March 11, 2024

TO : All Bidders
FROM : Bob Lavey
PROJECT : Nogales High School New Building and Aquatic Center
Project W2110000AR.41
DSA : 03-122782 / File 19-92
SUBJECT : Addendum 3

DRAWING NUMBER: **T1.1**

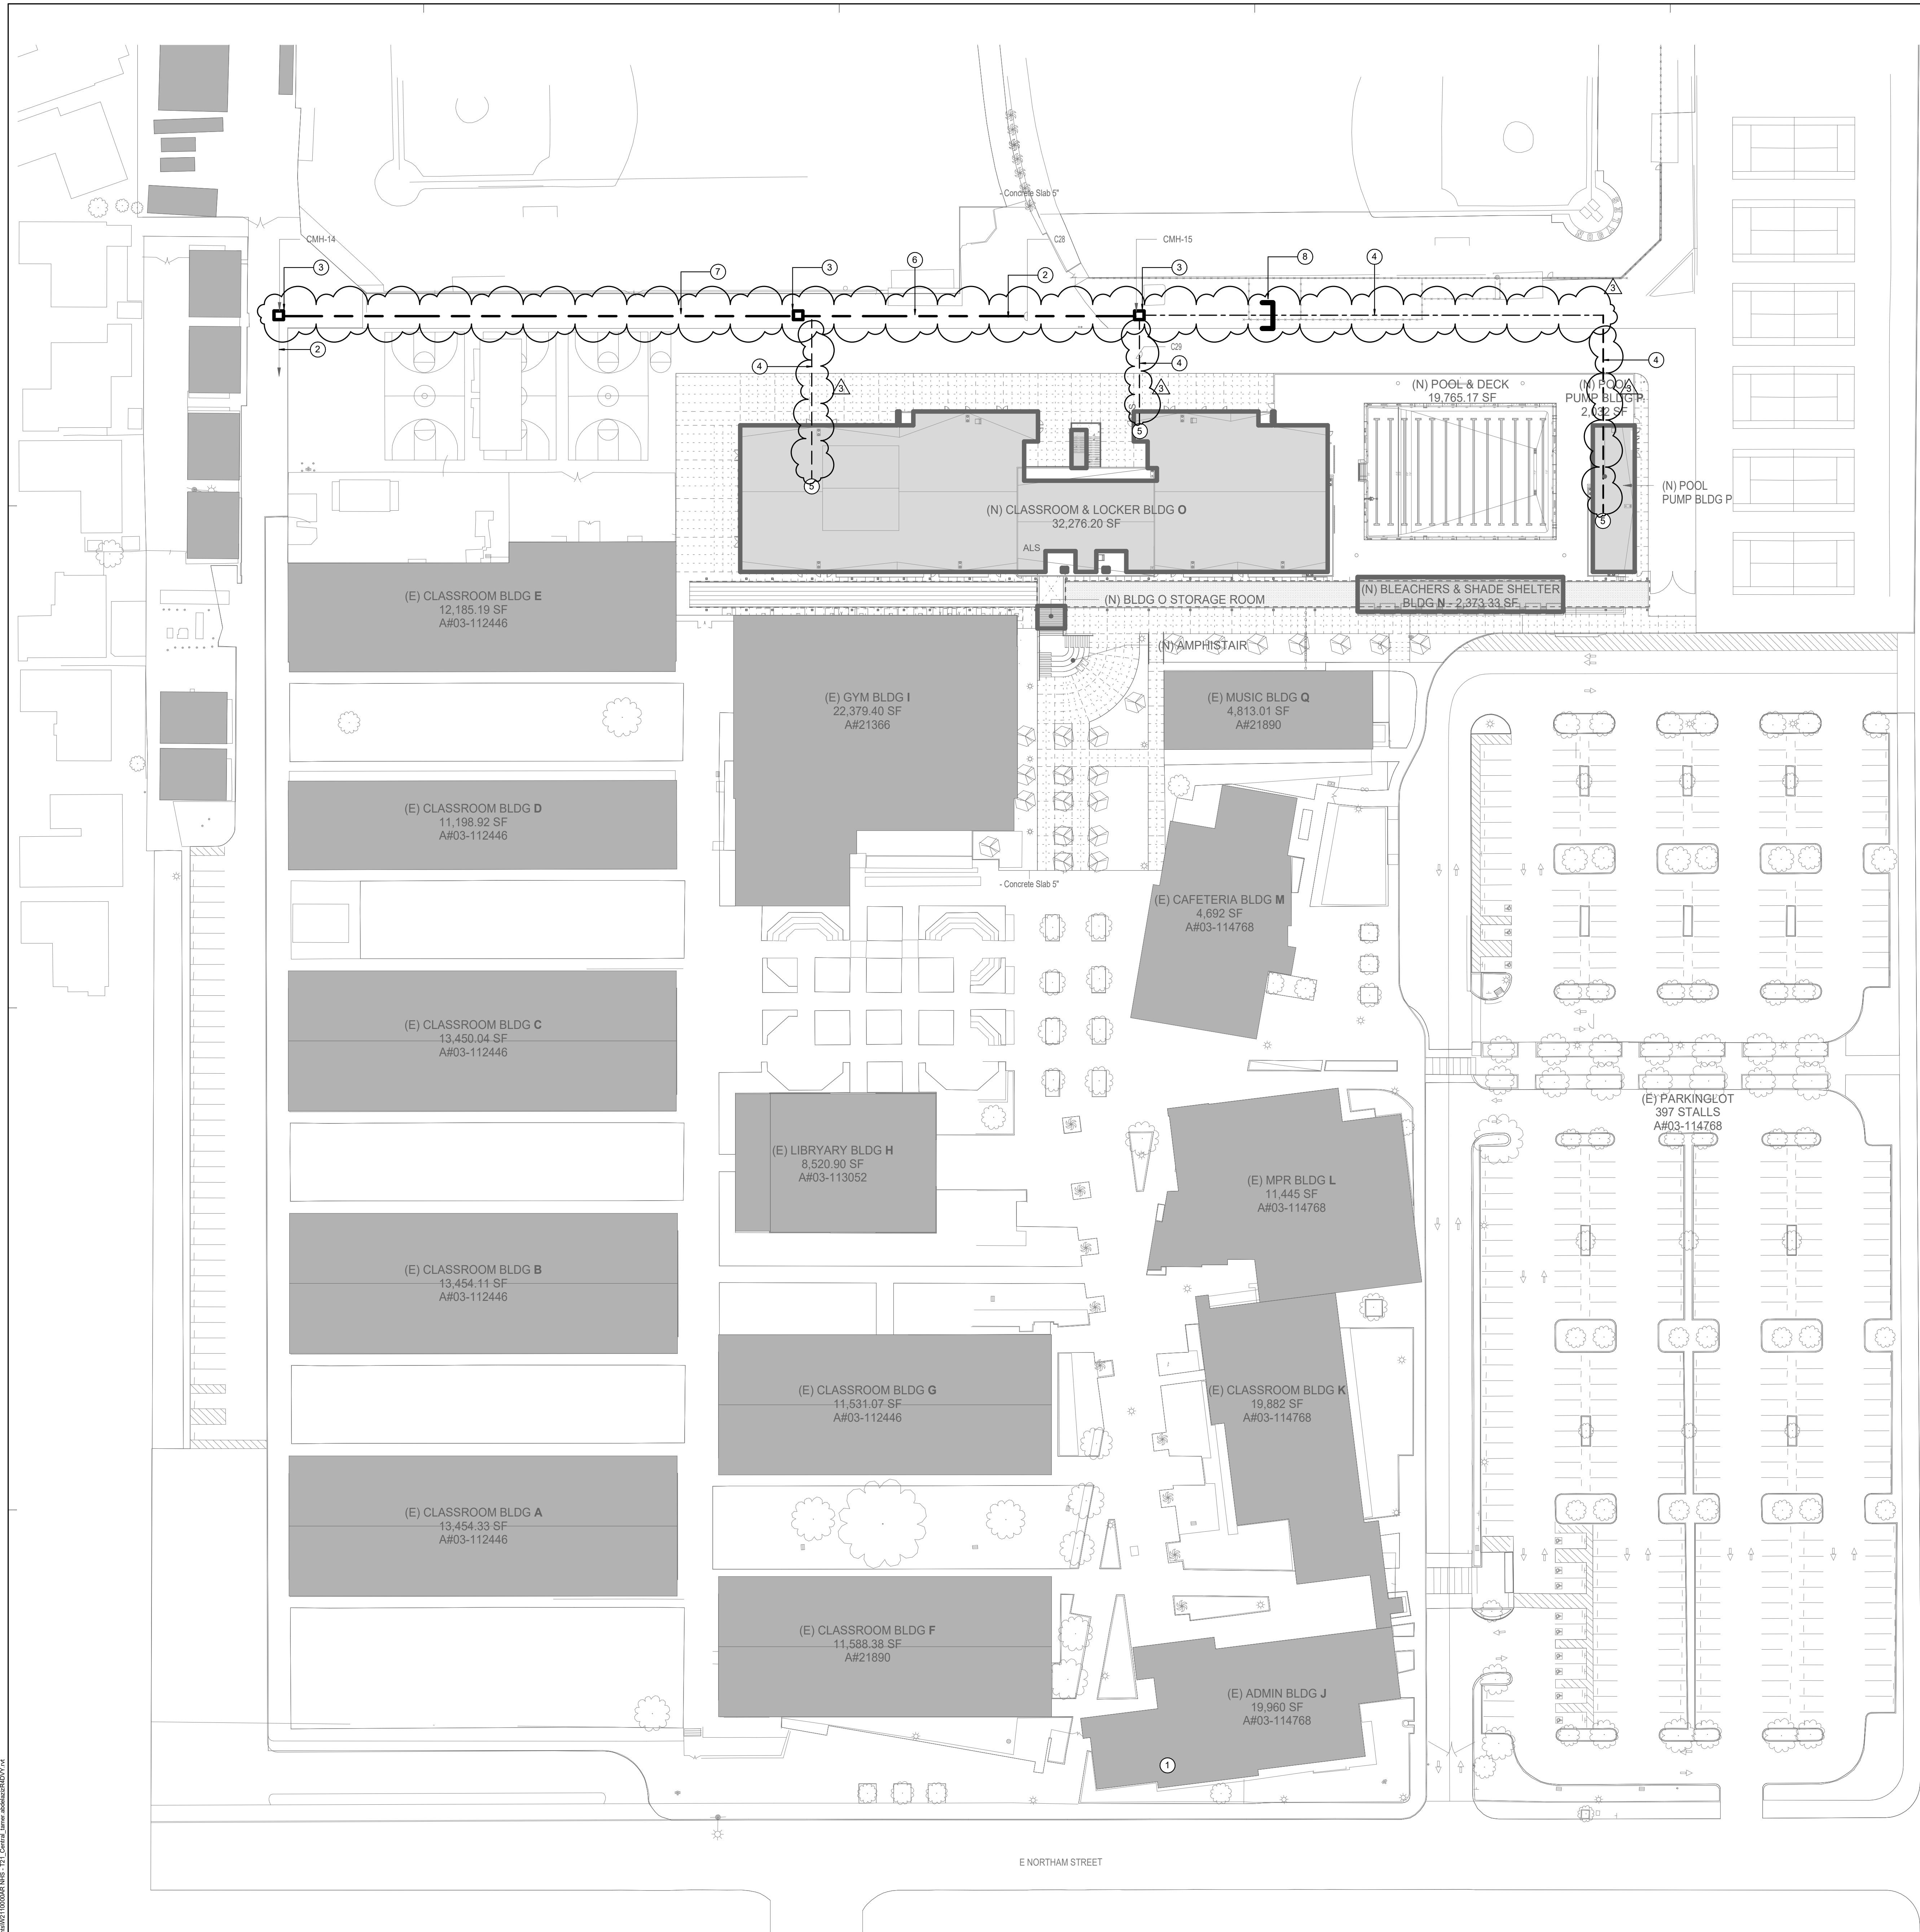
- A. Replace this drawing in its entirety with the attached Drawing T1.1.
- B. Revise point of connections between new conduits and existing per the attached Drawing T1.1.
- C. Add information for the existing MDF, existing conduits and junction boxes locations per the attached Drawing T1.1.
